Docket Item #16  
BAR CASE# 2005-0028

BAR Meeting  
March 2, 2005

**ISSUE:** Addition and alterations

**LOCATION:** 309 South Lee Street

**Figure 1** Proposed North elevation

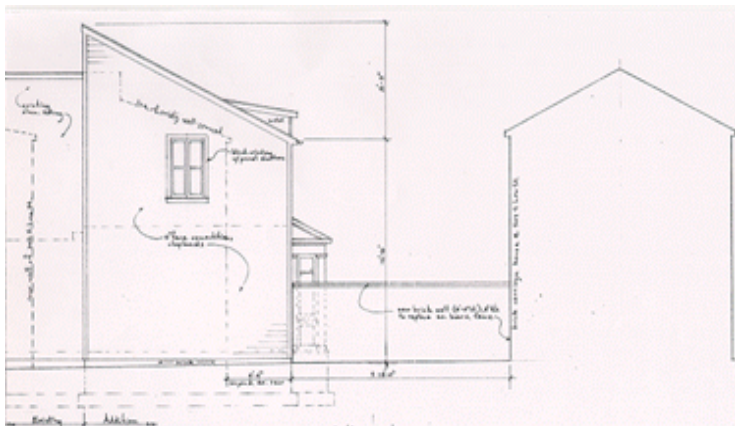
The north elevation, located along the property line will have a blind window located at the second story level with panelled wood shutters. The west elevation includes a one story bay measuring 3' in length by 9' in width. The bay will have three six-over-six windows above a single wood panel. The bay also includes decorative wood columns and a copper standing seam roof. Centered above the bay window at the second story is a through the cornice dormer with a pair of multi-light windows.

**Figure 3** Proposed South elevation

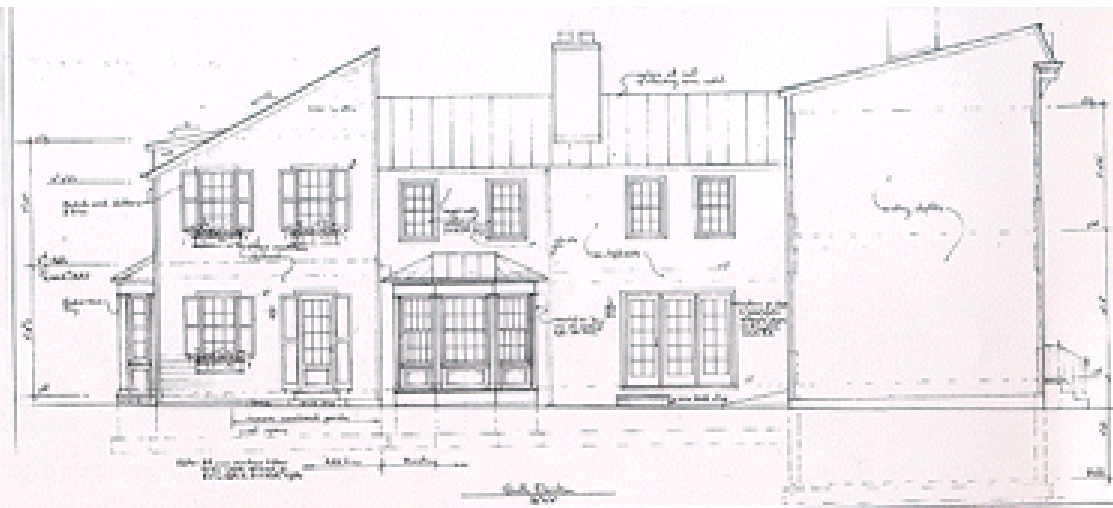
The south elevation includes one window and a door on the first story and two windows on the second story. The three double-hung six-over-six windows have planter boxes below. The proposed door has 12 lights above a single wood panel. All of the openings on the south elevation of the addition will have wood panelled shutters.
